**Re: Responses to Comments, Revised Remedial Investigation/Feasibility Study
Work Plan, Koppers Pond, Kentucky Avenue Wellfield Site, Operable Unit 4,
Horseheads, New York**

ATTACHMENT A
RESPONSES TO COMMENTS
REMEDIAL INVESTIGATION/FEASIBILITY STUDY WORK PLAN
KOPPERS POND
KENTUCKY AVENUE WELLFIELD SITE, OPERABLE UNIT 4
HORSEHEADS, NEW YORK

FIGURE 8
PROPOSED POND AND OUTLET CHANNEL
SAMPLING LOCATIONS
KENTUCKY AVE. WELLFIELD SITE - OU4
HORSEHEADS, NEW YORK

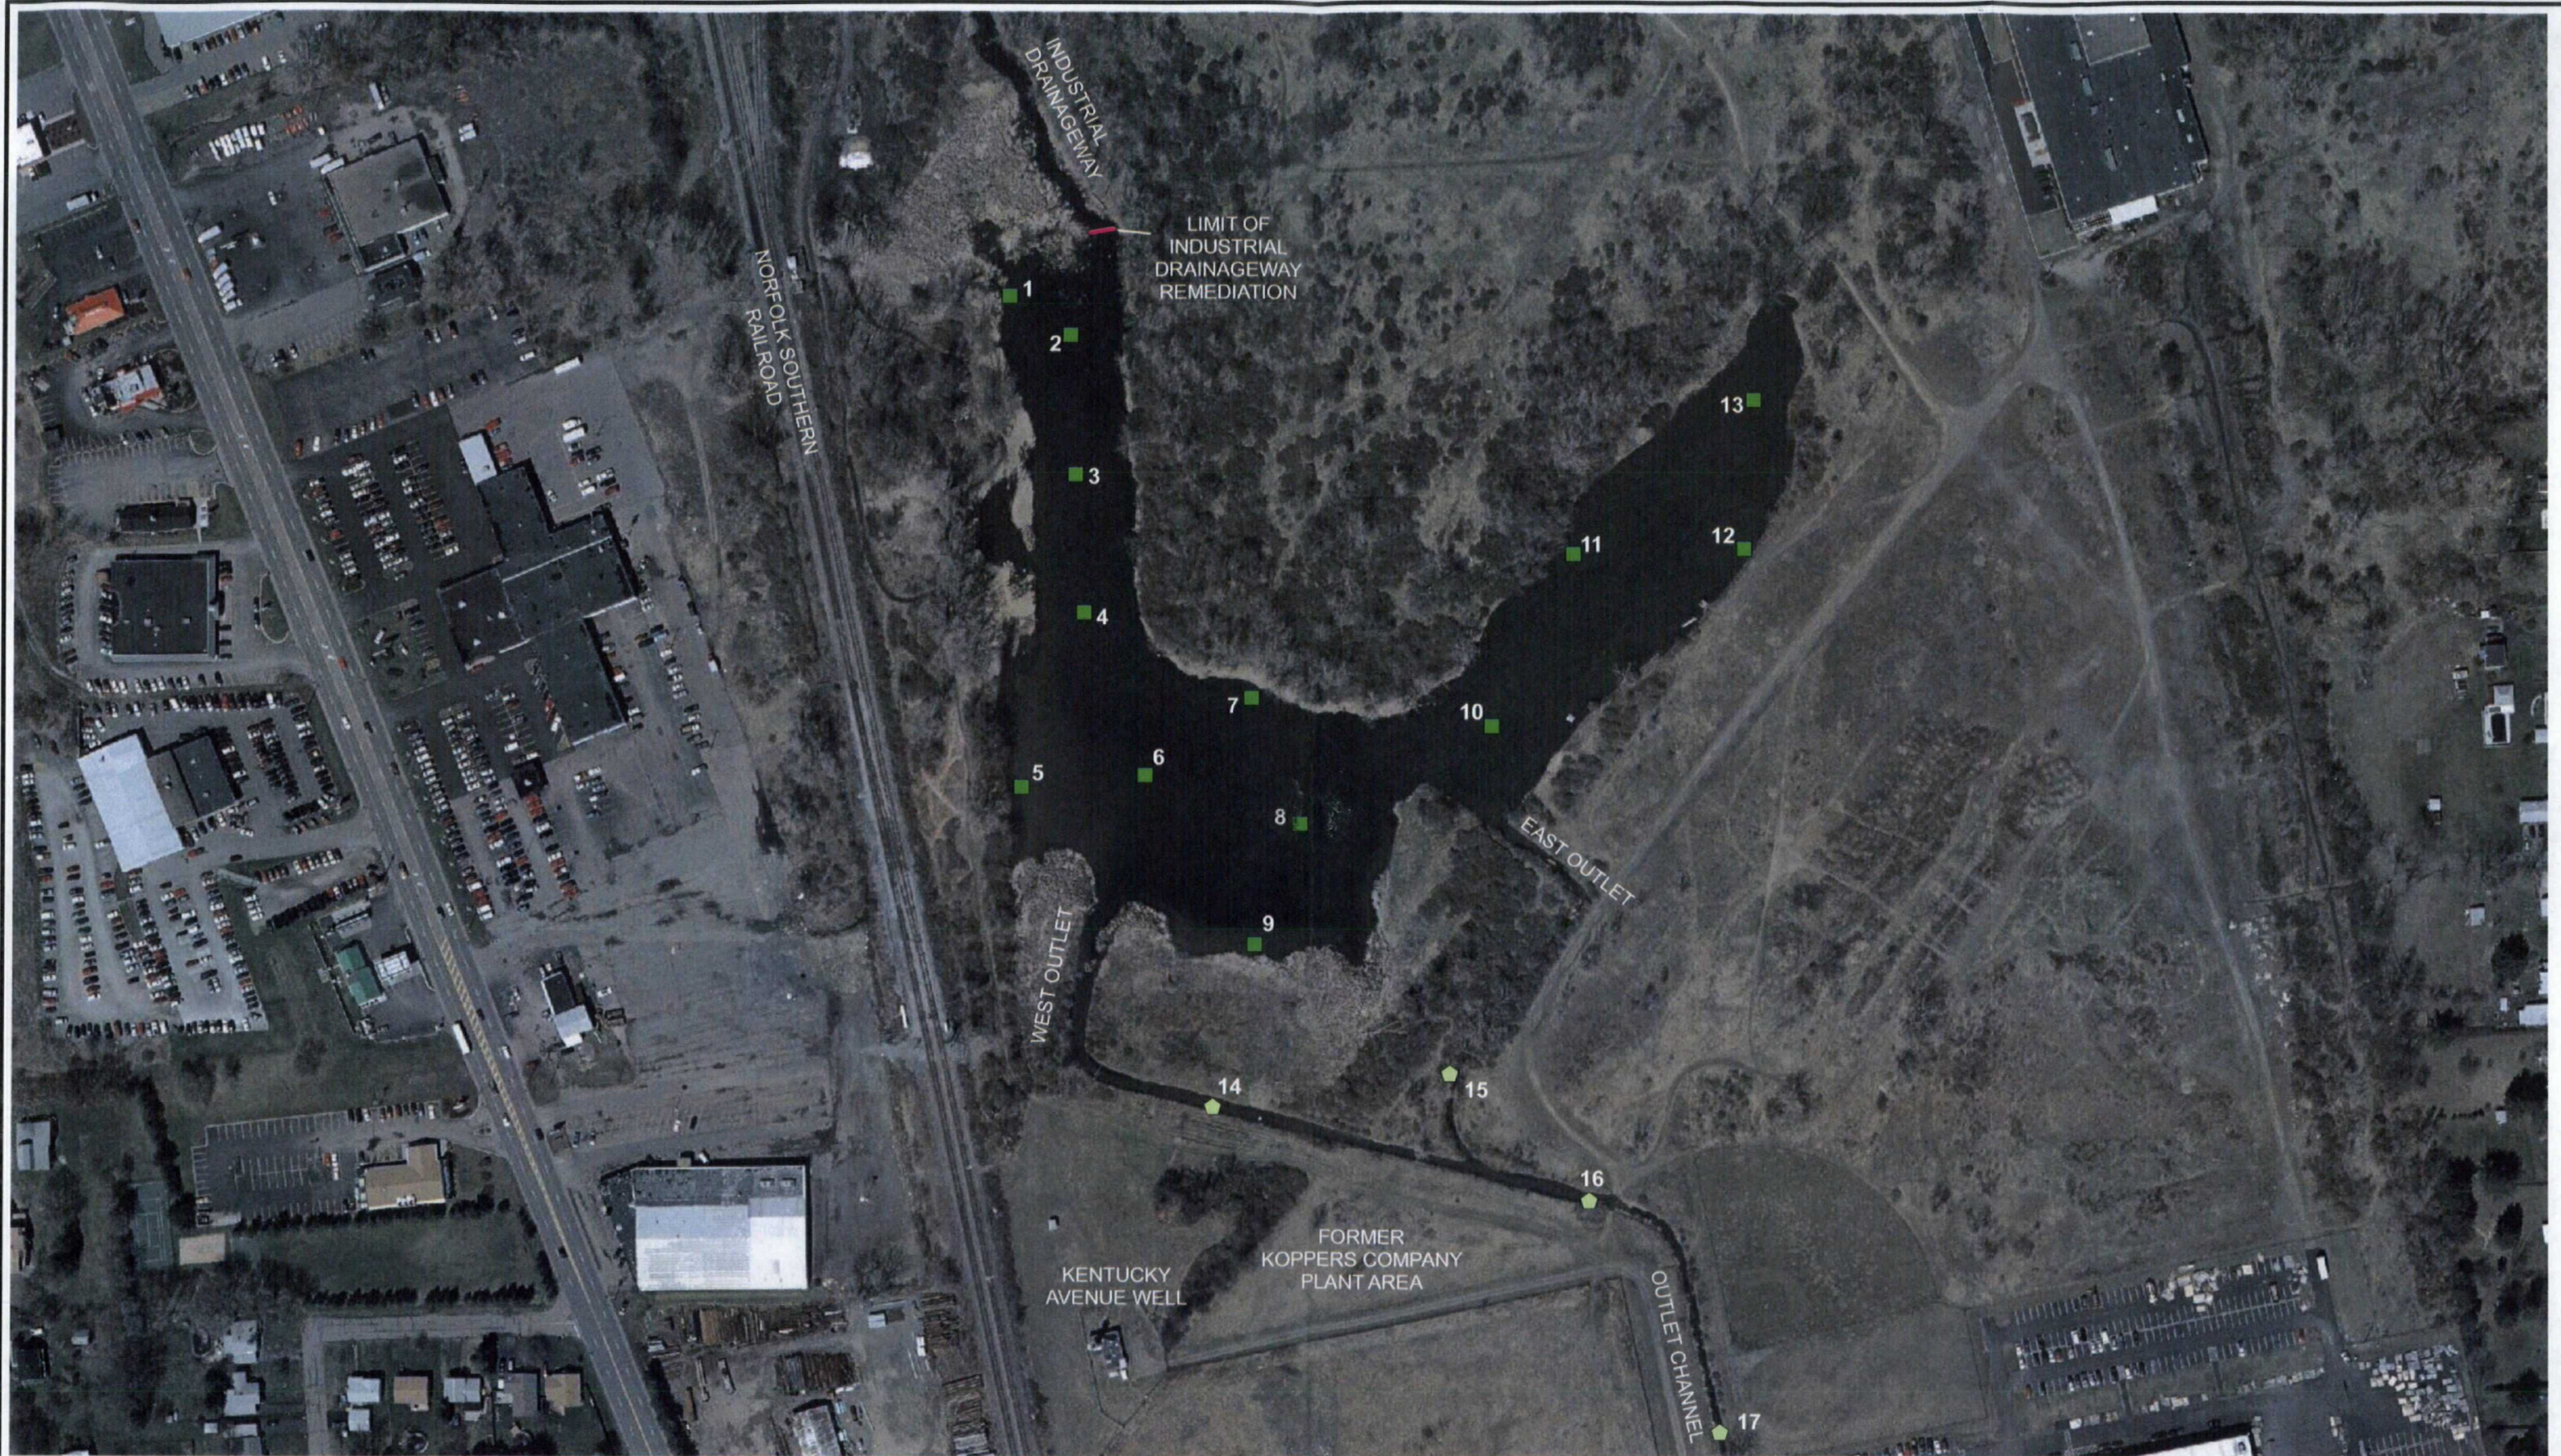
3. Page 47 - Section 6.3.1.2 - Task 3.2 - Surface Water and Sediment Sampling - Please add another near-shore shallow sediment sample location on the northern side of the pond, in the Eastern half.

As shown in the attached (revised) Figure 8, sample locations have been adjusted to ensure a sample is collected near the north shore of the east leg of the pond where the pond abuts the Old Horseheads Landfill.
